# SUBMISSION TO INLAND RAIL NARROMINE TO NARRABRI EIS.

## A4. Consultation

EIS Chapter 4 and appendix C do not represent an accurate account of the consultation process undertaken at Narromine for the Narromine to Burroway Section (N2B).

**Extract from: October 27<sup>th</sup> 2016 MCA Report**

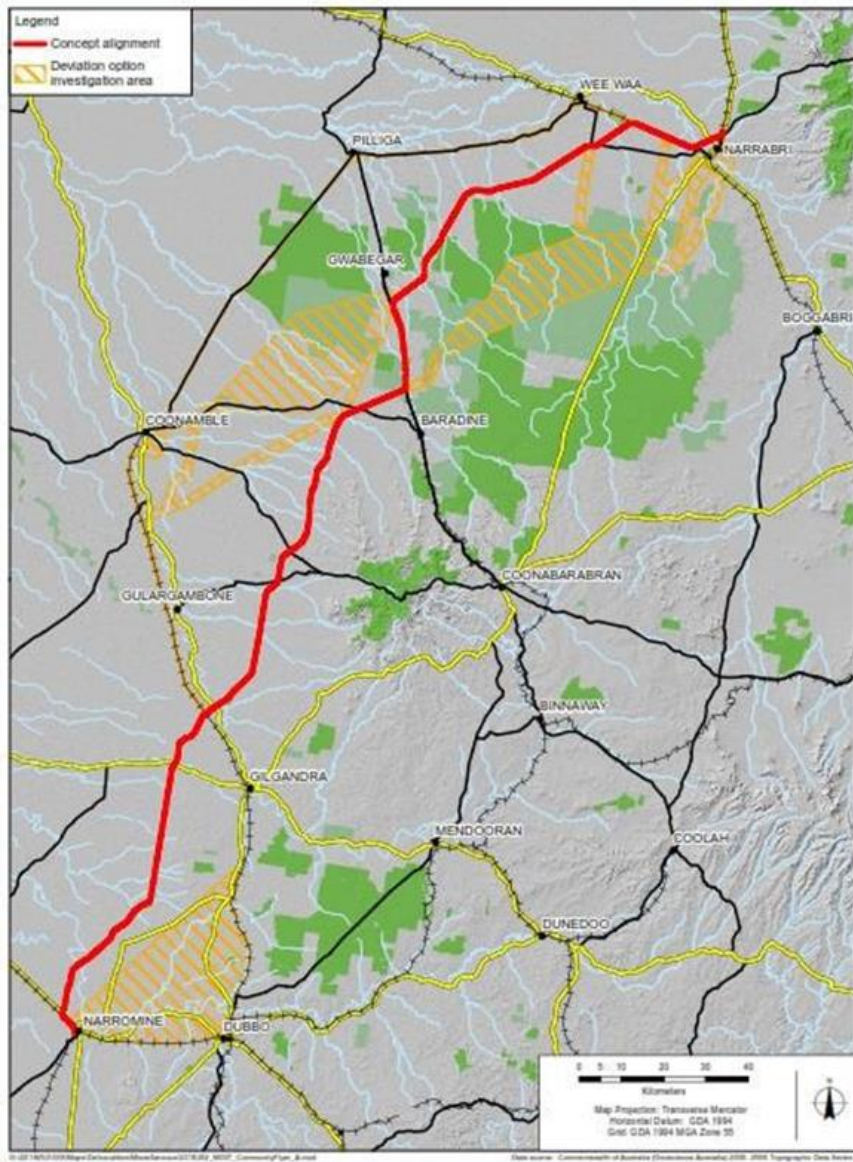
A major issue is apparent with this map.

All the farms and residential estates south of the existing Dubbo to Narromine rail line are outside the ‘deviation option investigation area’. There is also a large gap, over 10km wide between South Eumungerie and Gilmores Roads with no way to join the ‘deviation’ area with the concept alignment.

This map formed the basis of the ‘fact sheet’ that was put in landholder mailboxes in March 2017. Landholders South or East of Narromine who read this ‘fact sheet’ would never consider the Inland Rail project impacting their properties unless they were directly adjacent the Parkes to Narromine rail line.

No additional project maps were developed so why did ARTC diverge from their documented plan? Who approved it? Why was no updated map produced to ensure consultation work could meet the above principles of Inclusivity; Transparency; Equitability; Accessibility; Materiality; Responsiveness and IAP2 standards?

## March 2020 Focus Area

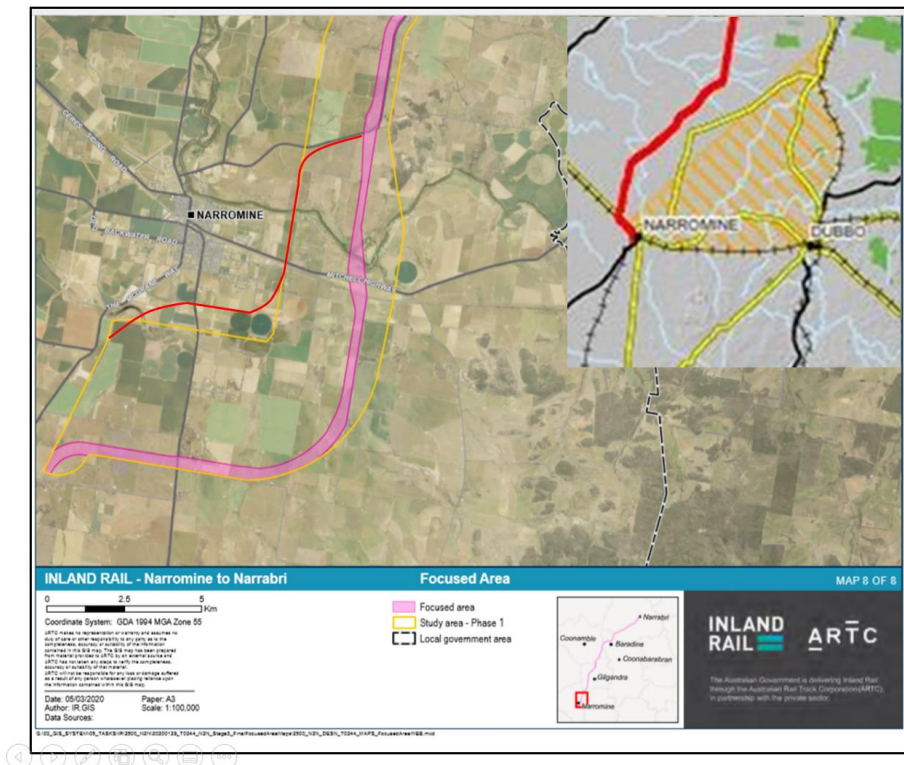
Note: The final MCA study route is outside 'Deviation Options' and final 'Study Area'. It is also many kilometres from final 2020 alignment.  
The route selection data is now completely wrong for the N2B section.

As can be plainly seen, the Final 2017 MCA study route is outside the Ministerially approved 'Study area phase 1'.

It is also a very long way from the Focus area where the EIS alignment is now located. Any field work or desk top evaluations undertaken for the N2B MCA are inaccurate and I submit, invalid. The MCA alignment study area is not only outside the Ministers approved study area, it is on the Northern side of the Backwater Cowal on a completely different landform. This impacts all MCA scores – cost, flood exposure, Geotech/constructability, biodiversity, cultural heritage assessments. Note how far outside the 'Deviation option investigation area' the Focused area is, approximately 10km further South. Impacts on the MCA score include:

Figure 3-3 Parkes to Moree overview

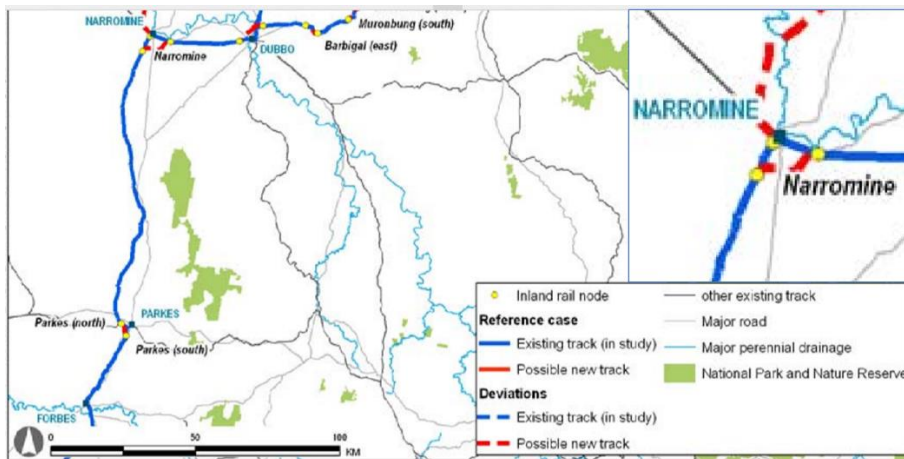
As can be plainly seen the IRAS 2010 ‘Eastern alternative route’ is very similar to current EIS route around Narromine. The 2016/17 MCA documentation never disclosed that the 2010 IRAS study had evaluated the same alignment option south and south east of Narromine nor that the IRAS report reached a completely opposite conclusion from a flooding and constructability perspective. This is a significant omission by ARTCs MCA process.

The 2010 Eastern study area has also been removed from the FIGURE A6.3 EIS map. This omission needs to be corrected and the EIS must provide the data and rationale for overturning the IRAS 2010 findings so the methodology and conclusions can be transparently reviewed.

Figure 3-1 Narromine to Burroway options

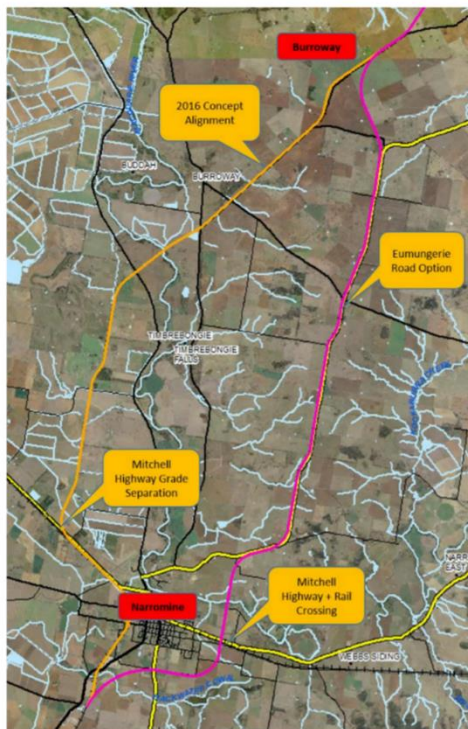
Incorrect  
49km & 34 mins

Geotec not  
accurately assessed  
see ARTC own limitations  
statements

Incorrect  
2020 Eumungerie  
Option 1% AEP  
exposure is 16 km

**Alignment length:** The Eumungerie Rd option alignment length quoted by the MCA is not representative of the final EIS alignment which is now 49 km. If consultation with local landholders had occurred regarding this corridor proposal it would have become immediately apparent that the Pink line was not tenable from a flooding and land use perspective (NB this is a historically proven point as the alignment was moved sometime between May & October 2017).

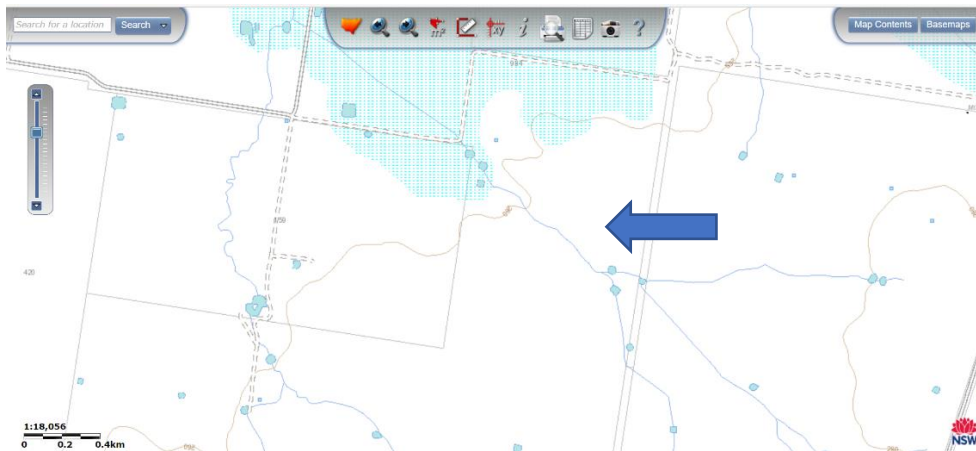
- The North – South running Inland Rail N2B alignment is positioned in the middle of the Webb's Siding outflow.
- An existing East – West rail embankment sits between the outflow origin (the Macquarie River) and its destination (the Backwater Cowl).

- The embankment has limited culvert drainage to relieve outflow flood waters.
- The embankment is assumed to be able to hold back the flood waters despite being comprehensively overtopped by ARTC's own March 2020 flood model (a model which excludes town levee construction afflux and 23% climate change rainfall escalation).

- According to local experience the extent and depth of the Backwater Cowl 1% AEP flood model reads closer to a 10% AEP event and appears to be missing large areas of tributary catchment.

- The project has not run models other than the intact embankment assumption. It is indisputable that should an embankment failure occur it will result in a surge of flood waters entering the Backwater Cowl landscape. The associated erosive and destructive force of this surge will be channeled downstream with farm and rail infrastructure at risk. There is a heightened risk that combined with a coincidental 1% AEP peak in the Backwater Cowl flood waters, the surge could initiate an Inland Rail project embankment failure resulting in a second, more destructive surge event sending flood waters rapidly downstream into Narromine via the Town Cowl.

## Inadequate EIS Bridging allocation for the Castlereagh River.

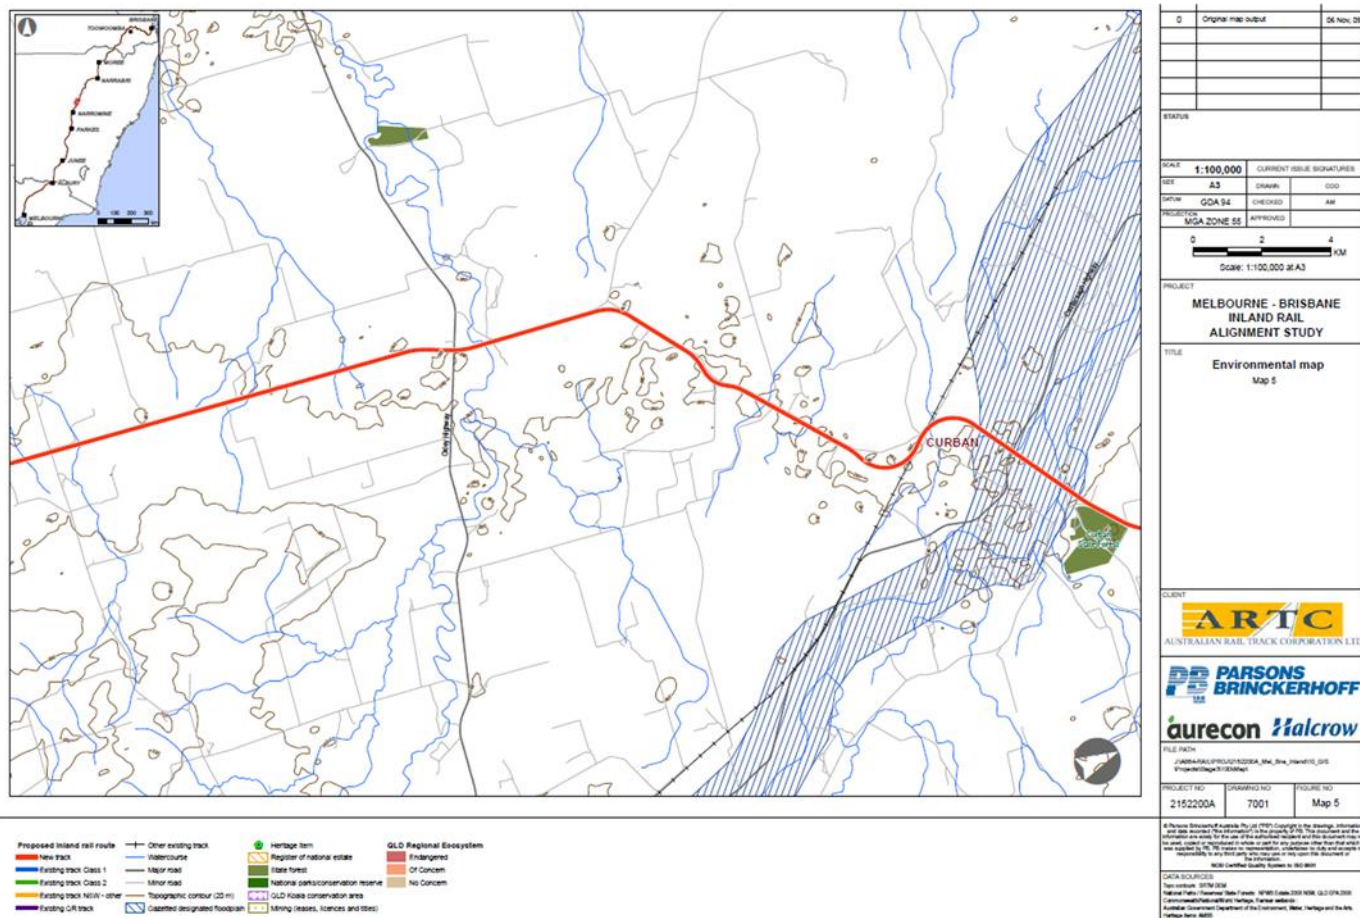
There is major issue with EIS Castlereagh bridging allocation (of 805m) when the Castlereagh Flood Mapping study cites a flood width of 3.5 to 4km at the alignment crossing point. This crossing point is the same as the IRAS report and cited in IRAS Appendix J (see below).

It is self-evident that 805m of bridging is not sufficient for nearly 4km of Castlereagh flood plain. ARTC Castlereagh flood modeling is significantly smaller than the Gazetted flood study used by IRAS 2010. The EIS flood model needs to be reviewed and the inconsistency found. Significant damage to surrounding farmland and the environment will occur if ARTC funnels 4km of floodplain through a 800m gap.
